ECN for USB Power Delivery Specification Revision 3.2

Version 1.1, 2024-10

Title: ECN Wait in EPR_Request

Figure 8.133 Sink Port State Diagram

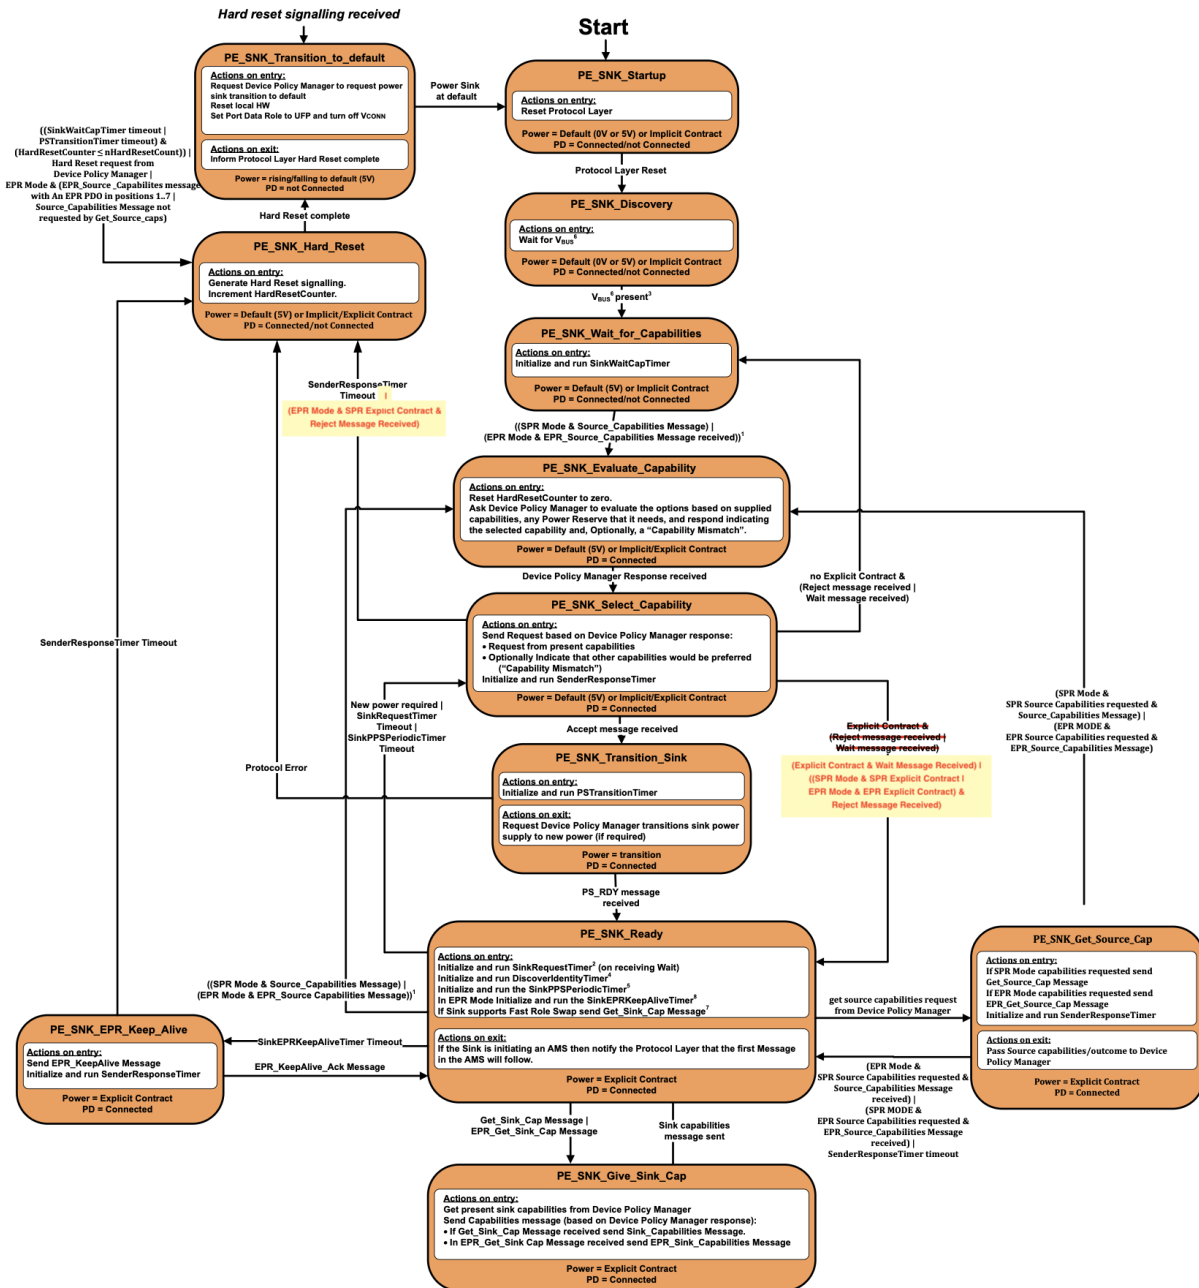
Minor changes to exit conditions in state machine. No new states

(b). Section 8.3.3.3, Page 835, Figure 8.133

- ~~There is an *Explicit Contract* in place and~~
- ~~A **Reject** *Message* is received from the *Source* or~~
- ~~A **Wait** *Message* is received from the *Source*.~~
- There is an *SPR Explicit Contract* in *SPR Mode* or an *EPR Explicit Contract* in *EPR Mode* and a **Reject** *Message* is received from the *Source* or
- There is an *Explicit Contract* in place and a **Wait** *Message* is received from the *Source*.

- A **SenderResponseTimer** timeout occurs; or
- An *EPR Explicit Contract* has not been established in *EPR Mode* and a **Reject** *Message* is received from the *Source*.
